Addendum #1

Project Name: Nebraska History Museum Renovation
131 Centennial Mall N.
Lincoln, NE 68508

Project No.: 13059-05

Documents Issued: August 20, 2014

Concrete Crack Repair Images

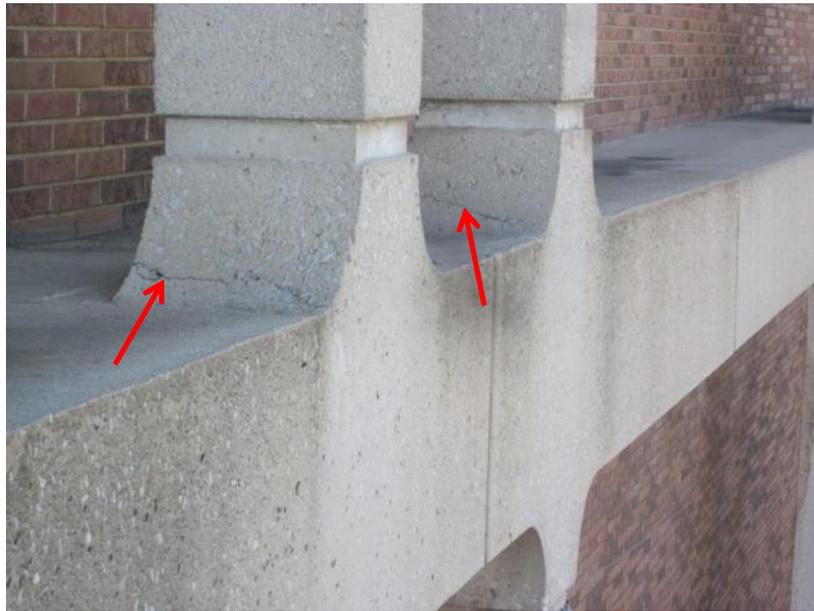
Response: Some of the cracks are visible from the street and have been noted on the A701 ceiling plan. Other cracks are not visible from the ground and have actually not been mapped but were indicated in a façade assessment report provided to the Design Team. The cracks typically occur on the exposed architectural concrete surfaces near the bottom of columns where they are framed into spandrel beams. Refer to **Attachment A1** for photos showing a representation of the cracks that will require repair.

ED100a

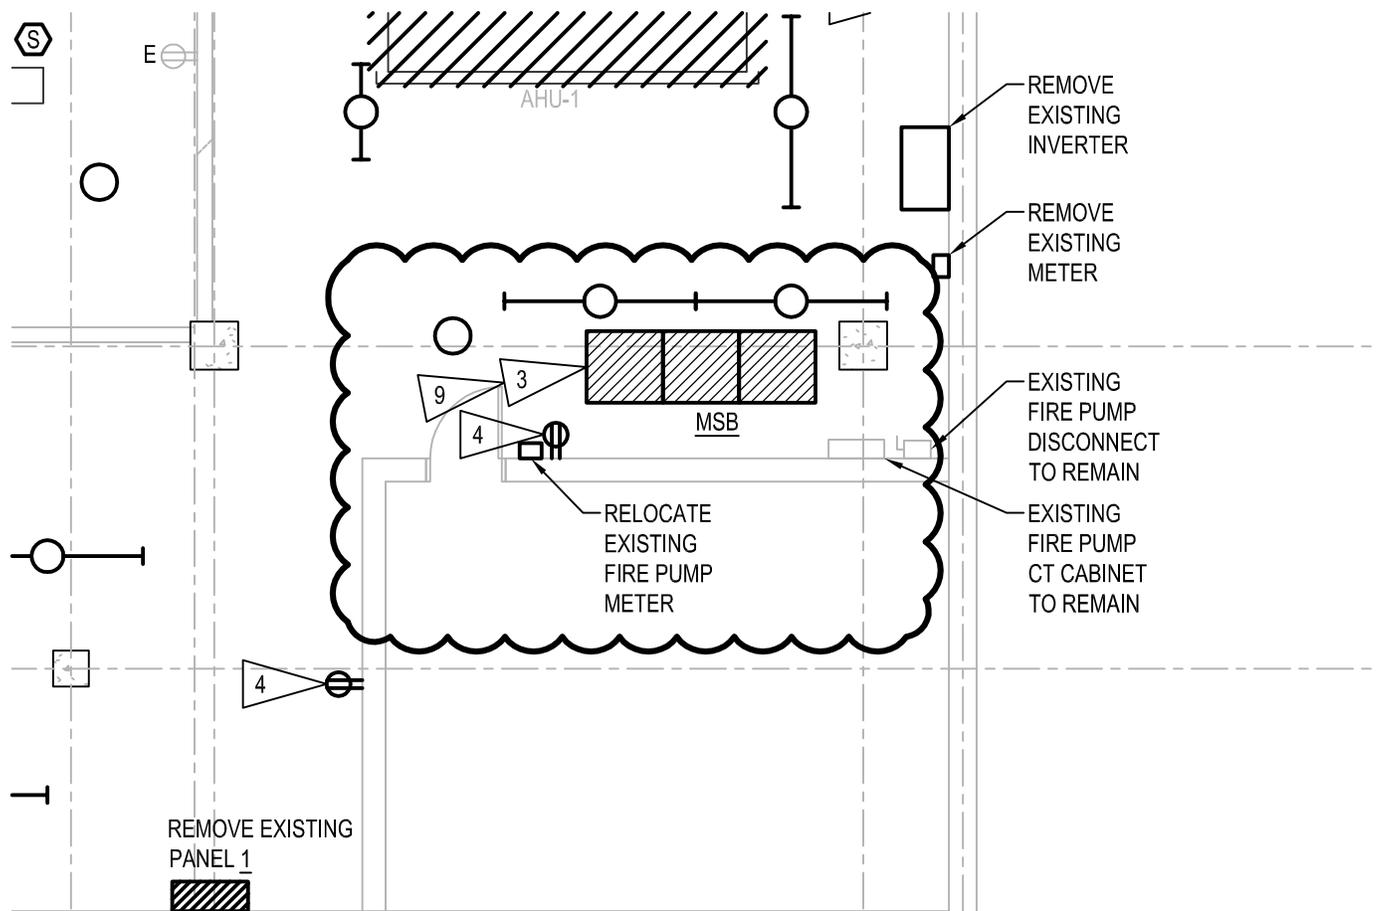
1. Remove existing underground feeders to Main Switchboard, cut below grade and patch floor. See attached **Sketch ED100a**.

8 REMOVE POWER CONNECTIONS TO EXISTING ELEVATOR.

9 CUT EXISTING CONDUITS TO BELOW FLOOR AND FILL SO THAT FLOOR IS FLUSH.

sketch **E100a**

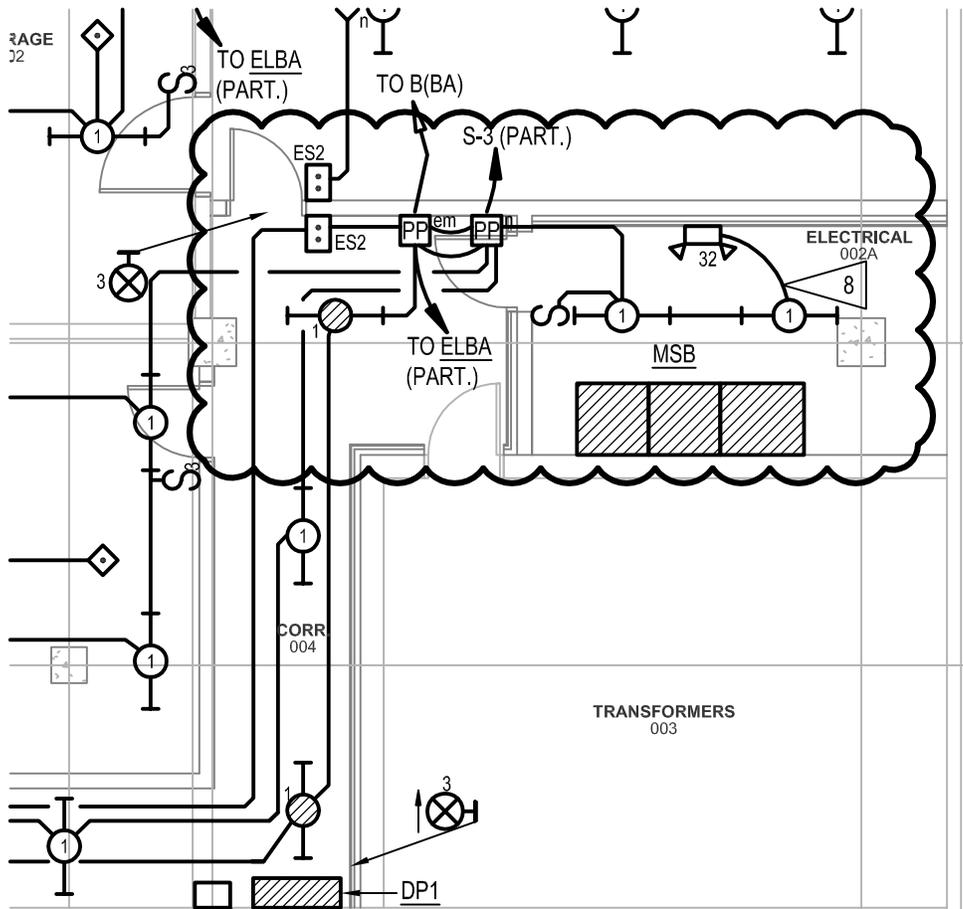
ADD 1-16. Refer to Sheet A700, Room 002A; Rotate light fixtures 90 degrees so they appear as shown in attached **Sketch E100a**.

1. See attached **Sketch E100a** for revised lighting layout in Electrical 002A.

sketch **E200a**

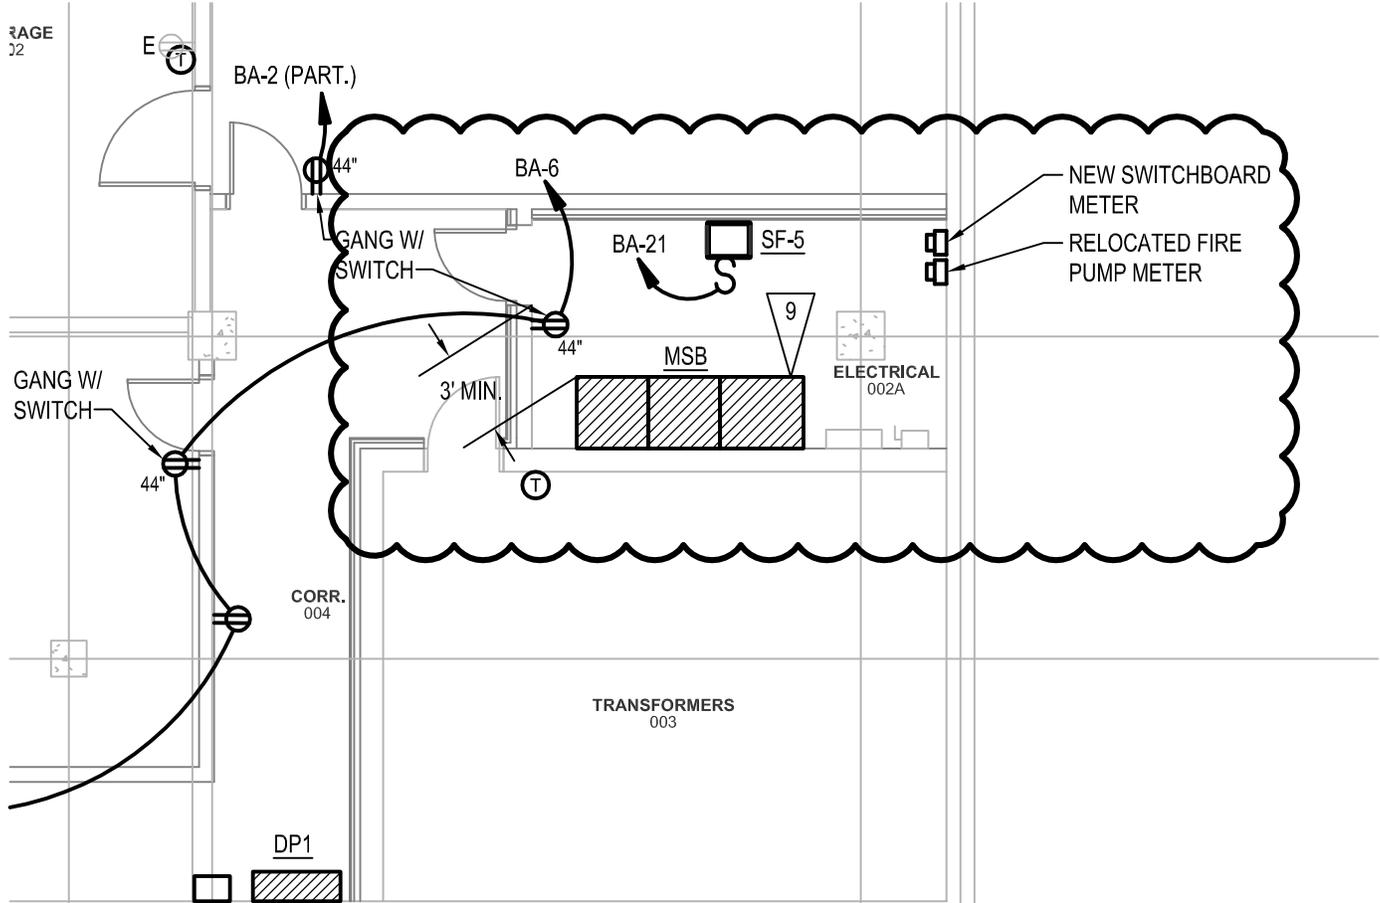
1. Revise layout of Electrical 002A per attached **Sketch E200a**.

8 UNDER BASE BID PROVIDE CONNECTION TO CHILLED WATER PUMP CWP-1,2

9 CONFIRM NEC CLEARANCE WITH REVIEWED SHOP DRAWINGS PRIOR TO BEGINNING CONSTRUCTION OF NEW WALLS.
